# Jetter

**Technical Information  
Version Update**

**August 19, 2002**

**JX6-CON2 / JX6-CON3 Modifications  
from Version 3.001 to Version 3.004**

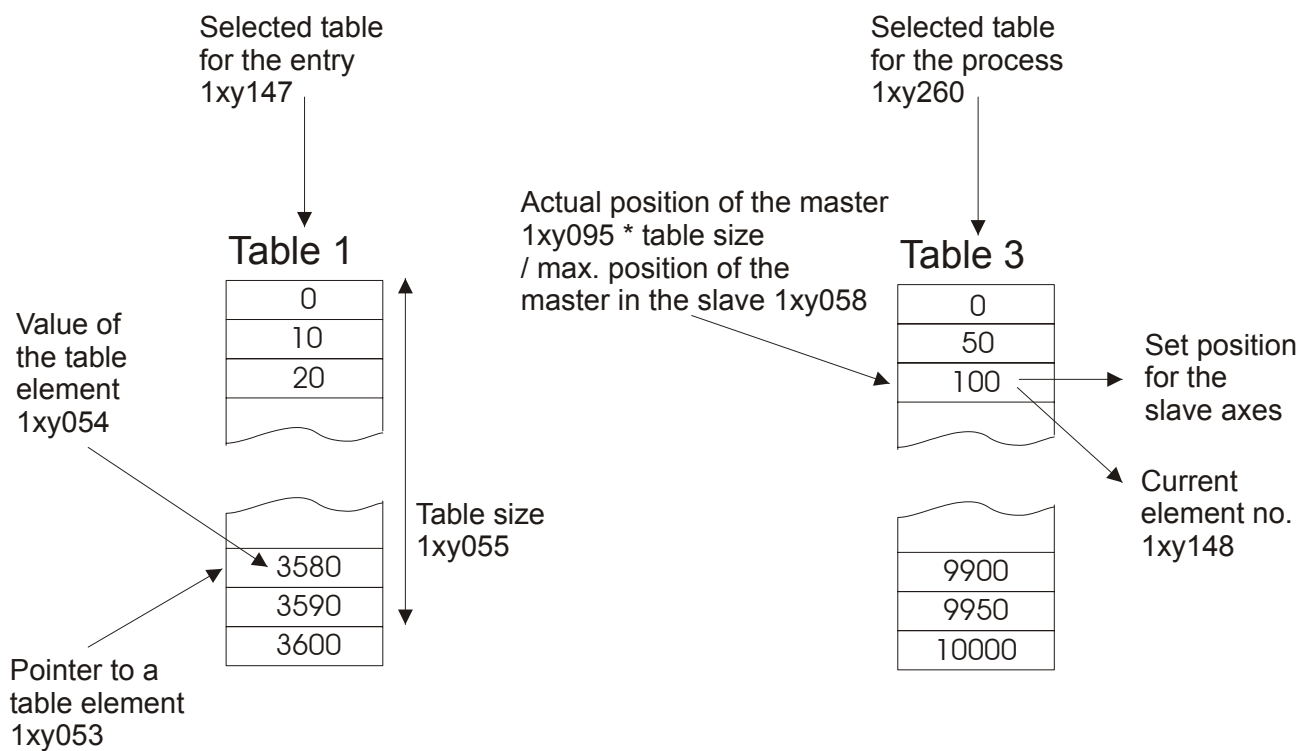
- (3.004) Starting from this version, the tables can be entered and processed separately. This means that it is possible to enter another table while a table is being processed. The new register 1xy260 serves to select the table for the process.

The following diagram illustrates the entry and process of various tables:

As in previous versions, different table sizes are allowed. As long as register 1xy260 is not written, register 1xy147 is used as selected table for the process.

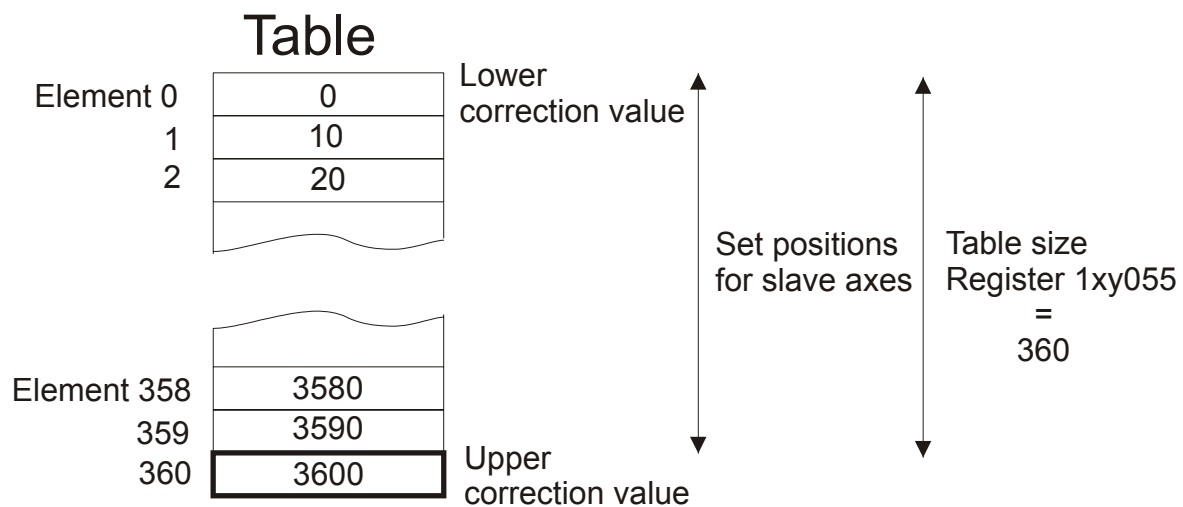
- (3.001) Using the acceleration limitation (register 60) with the follower only worked in one direction.
- (3.002) When recording the actual position in JetSym or Sympas oscilloscope mode, the values might have been incorrect.
- (3.003) Starting from version 2.900, an error might occur when creating a table if a table was written before using a too extensive table pointer.
- (3.004) Starting from version 2.900, the correction value during table mode overflow applied to the last table element. Starting from this version, the correction value must be entered again as additional element:

The correction value in case of table overflow is calculated as follows:

Correction value

= Value of the table element (register 1xy055) – value of the table element (0)  
 = 3600 increments – 0 increments = 3600 increments
